XENTRY TIPS

Model series 166 chafe mark on wiring harness - Bracket in center console is sharp-edged

Topic number	LI68.20-P-063996
Version	1
Design group	68.20 Center console
Date	04-29-2016
Validity	Model series 166
Reason for change	
Reason for block

Pic 1.jpg:

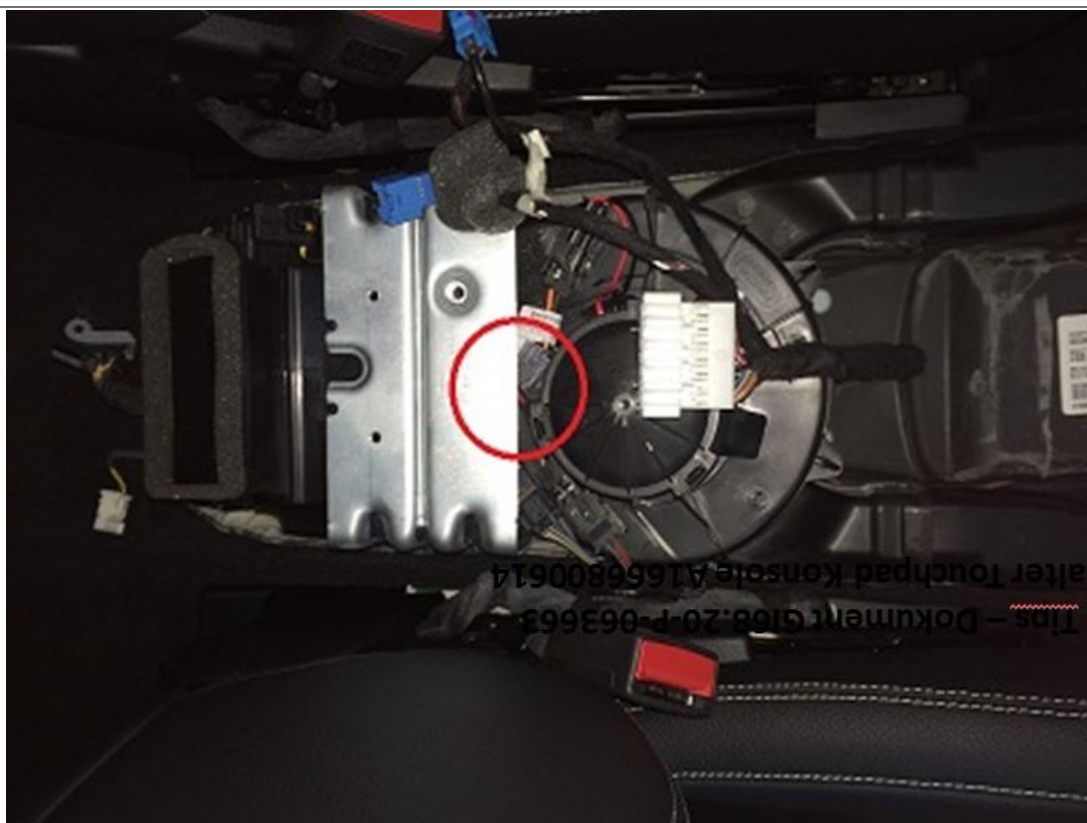
Wiring harness on booster blower or rear air flap may contact the metal bracket for the center console and suffer chafing (Pic. 1)

Attach felt 170 x 15 x 1 mm along entire length of front edge for center console bracket (Pic. 2).
